# The Sizewell C Project

## 9.73 Comments at Deadline 7 on Submissions from Earlier Deadlines and Subsequent Written Submissions to ISH1-ISH6 - Appendices

Revision: 1.0  
Applicable Regulation: Regulation 5(2)(q)  
PINS Reference Number: EN010012

Figure 1: Adult female Natterer's bat - MCP 95% comparison

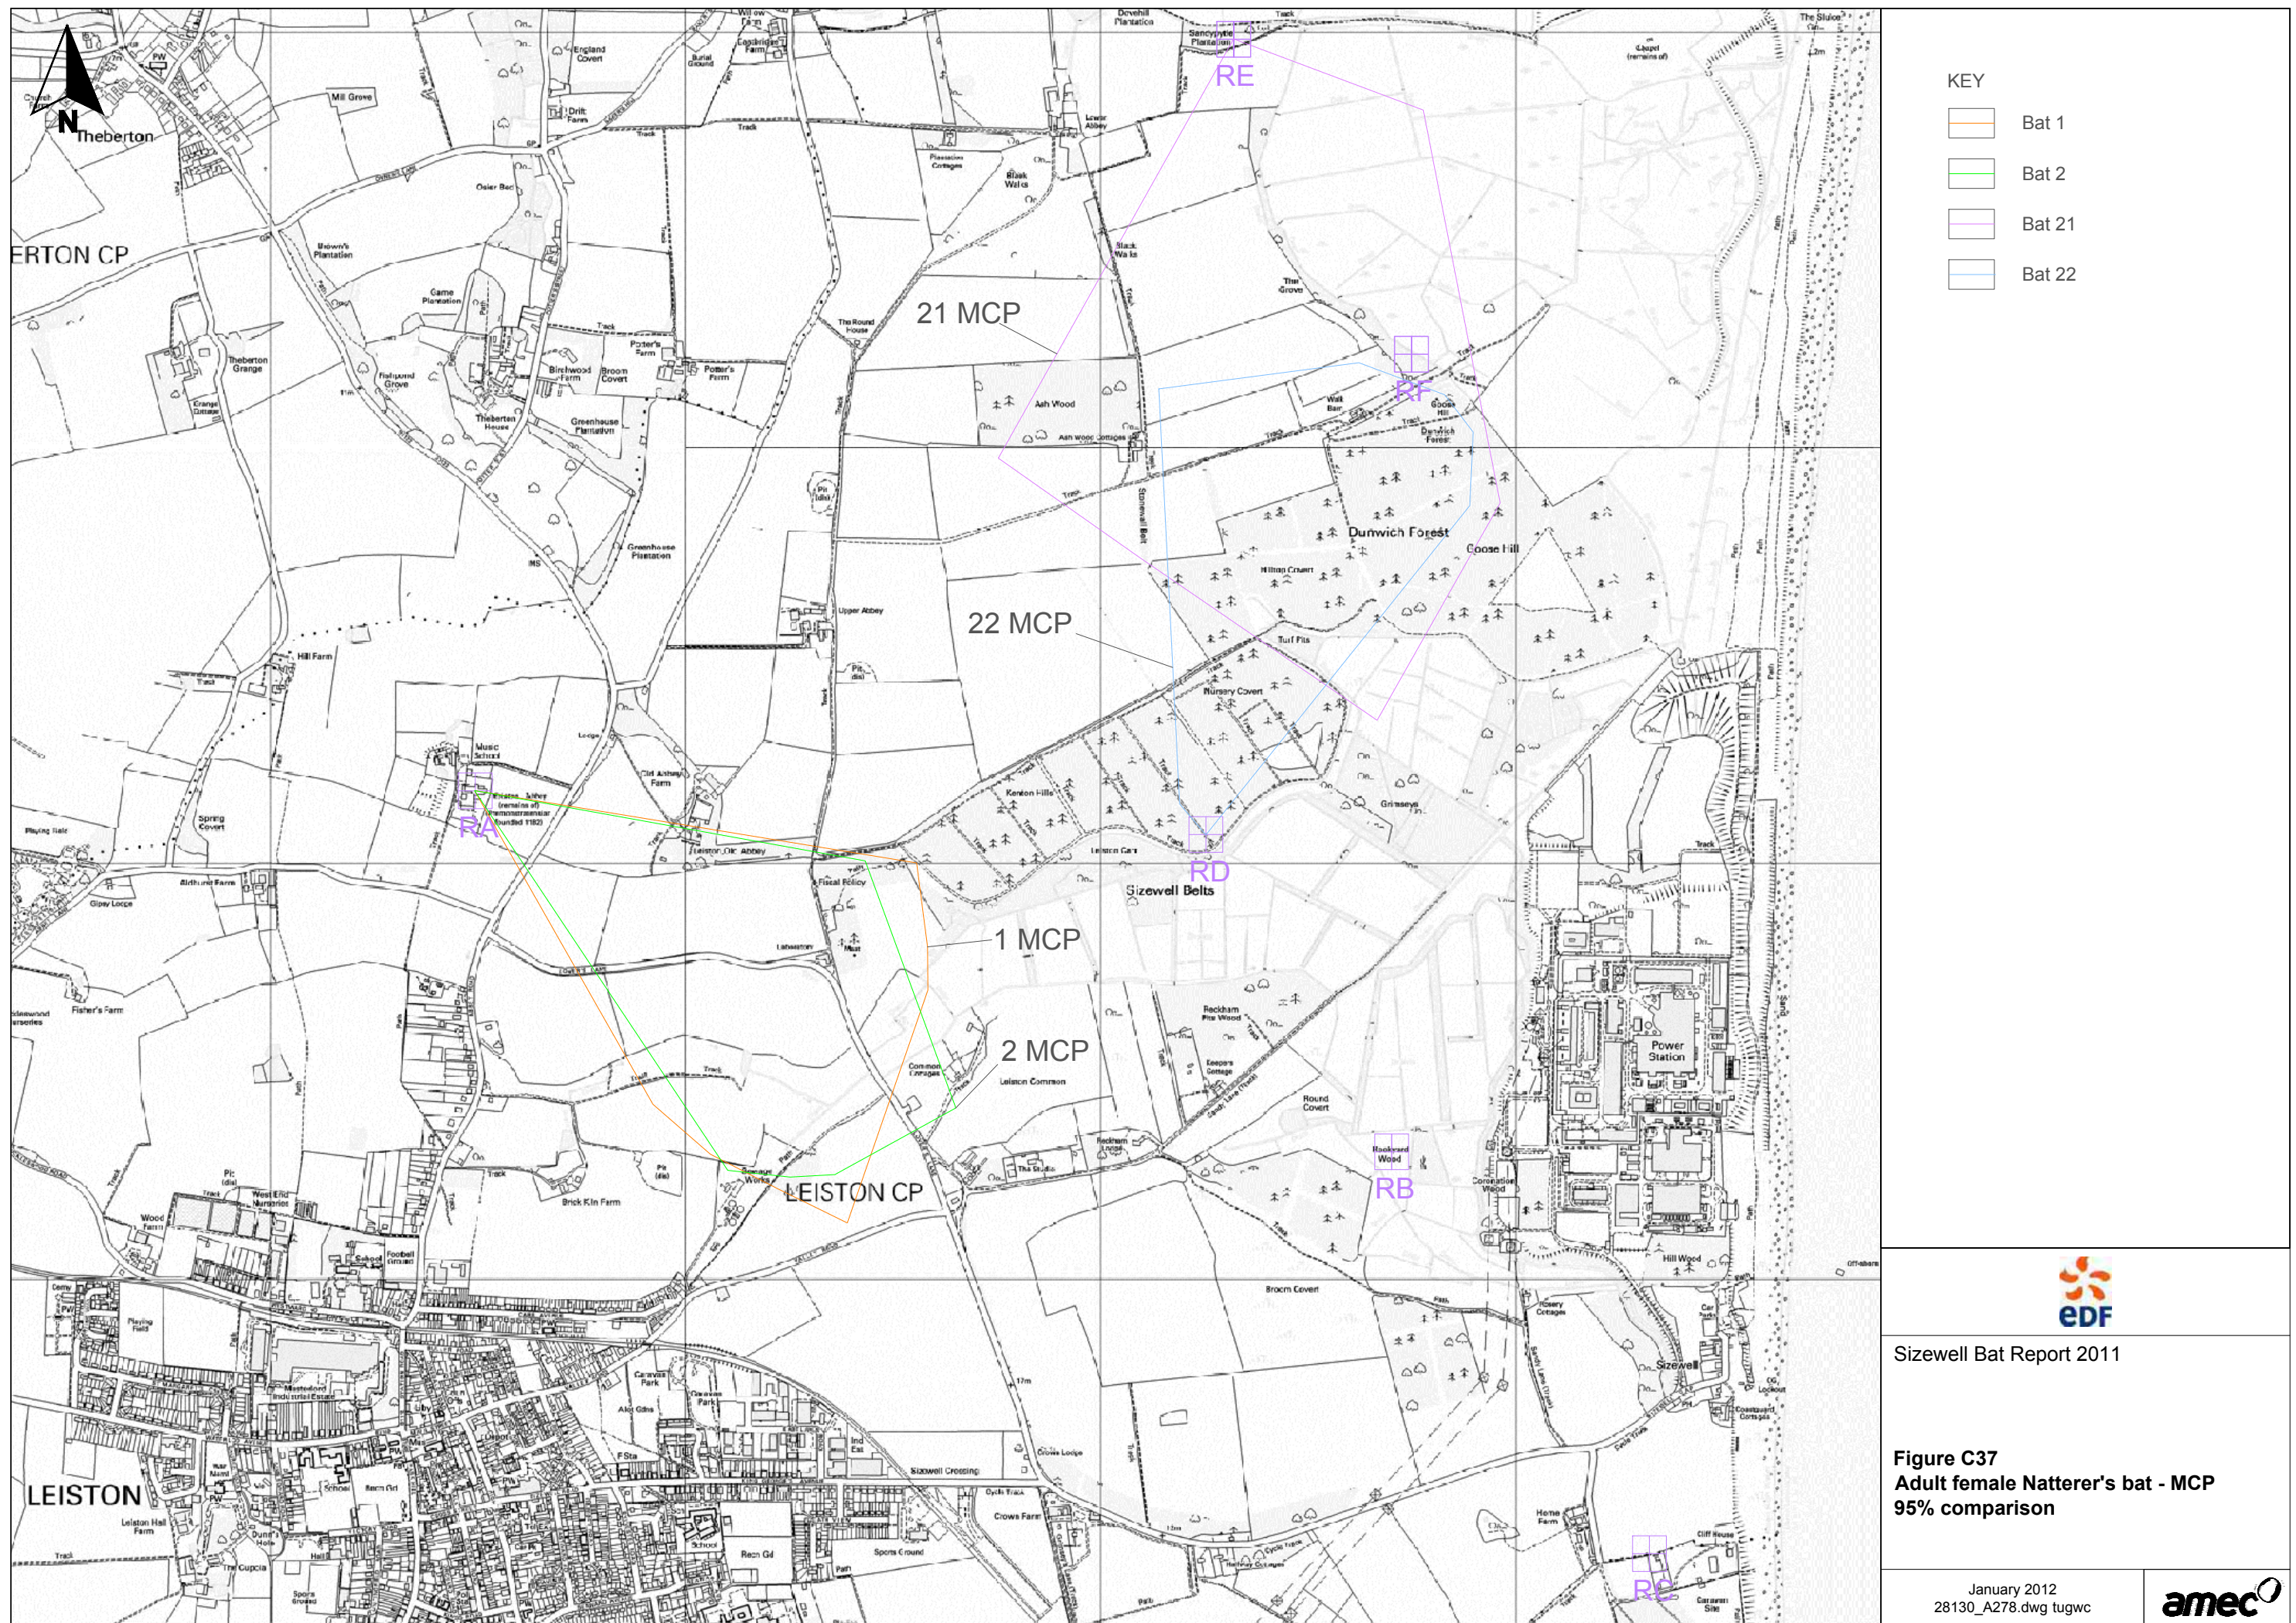
**General comment on the proposed construction phase commuting corridors for bats** – The bat mitigation strategy relies heavily on the maintenance of three habitat corridors through the site (Western – Bridleway 19; Central – through the Temporary Construction Area (TCA) Water Management Zones (WMZs) and Eastern – through the SSSI Crossing) during the construction phase. Notwithstanding our comments and concerns about the proposed routes set out in the table below, it is noted the Construction Parameter Plans secured by the DCO (most recently [REP2-008]) do not include these corridors. ESC consider that this is a significant omission given the importance placed on these routes for delivering ecological mitigation and request that they are included as part of the plans proposed for approval under the DCO.

SZC response: This document provides a response to the ESC responses. It also includes details of where further information was discussed in stakeholder meetings on 04/08/2021 and 24/8/2021
